4 May 2021
Our Ref: 20768B.8DK_s4.55_1A_RFI #1

**RE: 25-27 WARRIEWOOD ROAD, WARRIEWOOD
MODIFICATION APPLICATION No. 2021/0004**

This letter provides a response to the questions/comments raised in Council's email dated 22 April 2021 in relation to the need for a SWC and comments made in the Referral Responses. This letter should be read in conjunction with the following documents uploaded to the NSW Planning Portal.

Figure 1 Snap shots from architectural plans showing the approved and proposed basement wall location adjacent to Lorikeet Grove

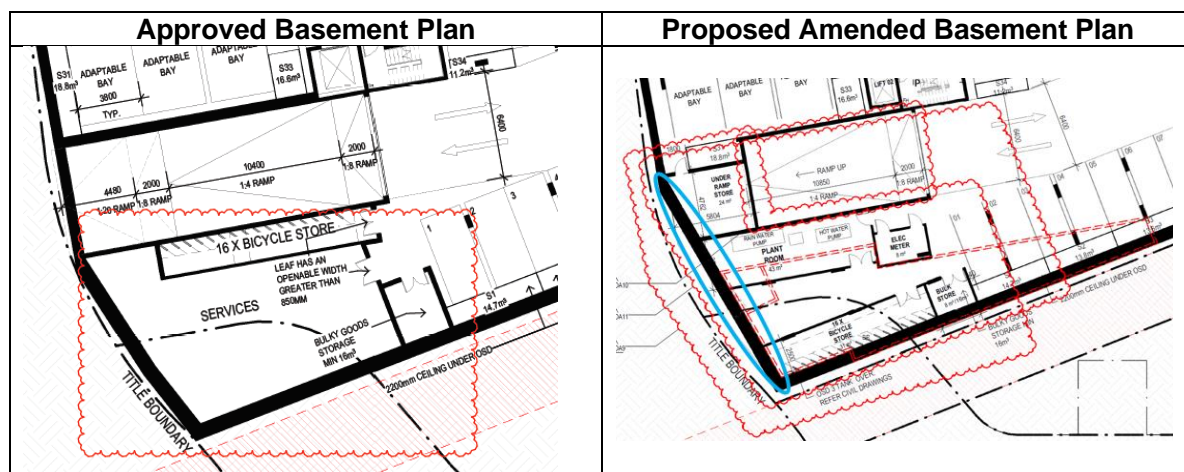
As per email correspondence between Janelle Pirone of Knowles Group and Council, there is a street light pole which is located inside the property boundary (near the basement driveway) on Lorikeet Grove. The light pole has already been installed and an easement has been created for the light pole.

The approved basement of the residential flat building did not accommodate the light pole. It is proposed to amend the basement by shifting the basement wall slightly off the Lorikeet Grove boundary. This amendment ensures that the basement is not located under the light pole. The snap shots in **Figure 1** compare the approved and now proposed basement plans in the vicinity of the basement driveway. The relocated basement wall is circled in blue.

Associated with this amendment is an amendment to the approved engineering plans to coordinate the location of OSD 3 with the amended architectural plans.
